September 27, 2021

Re: Narrowsburg Garage-Rooftop Café' Seating Addition
Review summary/comment letter

File: 1341.013.001

Spaces in barriers
and "shelf" like
width

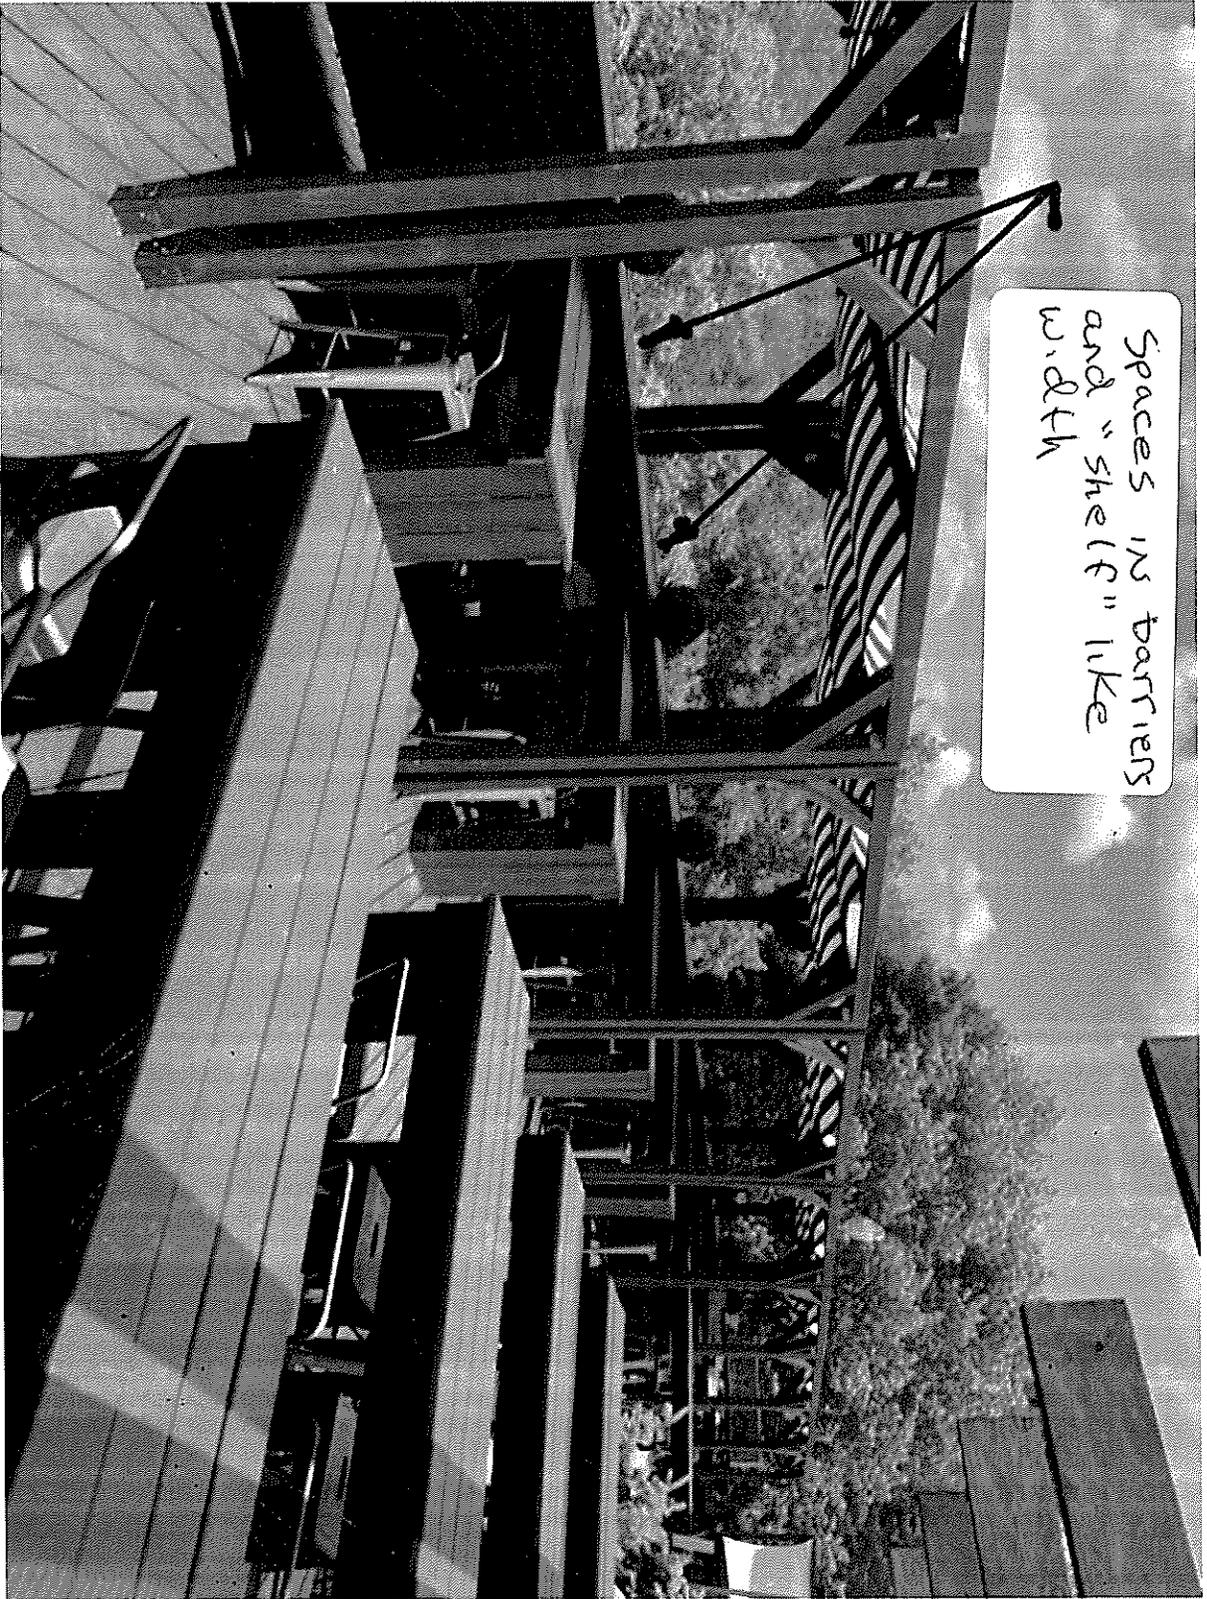
3. What are normal hours of operation?
4. A fairly wide "shelf" is adjacent to some of the tables that could be easily sat on and accessed from elevated high-top chairs and tabletops with no barrier to a fall from the roof. Small planters define the part of the space but not all of it. Signage warning of danger or a simple

barrier such as a cable to discourage sitting on it or placing drinks or other items that could be knocked off and fall on persons or property below. See picture enclosed of areas of concern.

wide spaces in railing system

"shelf" like width, concern for lack of barrier
